# UNITED STATES PATENT AND TRADEMARK OFFICE

APPLICATION NO.	FILING DATE	FIRST NAMED INVENTOR	ATTORNEY DOCKET NO.	CONFIRMATION NO.
10/825,690	04/16/2004	Mitsugi Chonan	032405R172	8856
441 7590 03/23/2007 SMITH, GAMBRELL & RUSSELL 1850 M STREET, N.W., SUITE 800 WASHINGTON, DC 20036			EXAMINER PILKINGTON, JAMES	
			ART UNIT	PAPER NUMBER
			3682	
SHORTENED STATUTORY PERIOD OF RESPONSE		MAIL DATE	DELIVERY MODE	
3 MONTHS		03/23/2007	PAPER

## Office Action Summary

## DETAILED ACTION

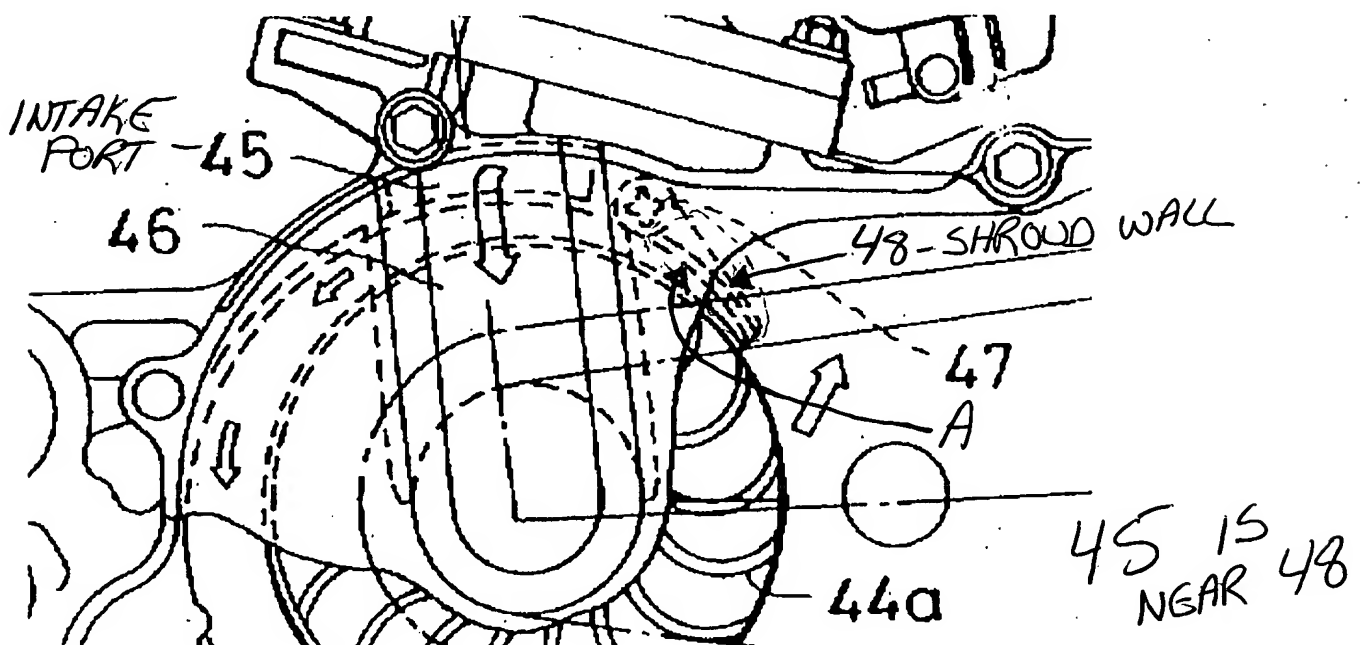
The examiner disagrees and directs the applicant to Figure 2 where it is clear that the shroud wall, defined now as character 48, is near the intake port 45. As no reference character is present in Figure 2 for the shroud wall see the Figure below.

The examiner disagrees and argues that Ikenoya discloses a wall 48 on which a scroll surface is formed (surface labeled in the Figure above as A). As broadly recited claim 1 does not set forth any structural limitations that differentiate the wall and scroll surface of Ikenoya from the instant application. Ikenoya does indeed disclose that 48 is the foot portion of a plate however, a plate is indeed a wall as it has a thickness and any surface of a wall is indeed a scroll surface.
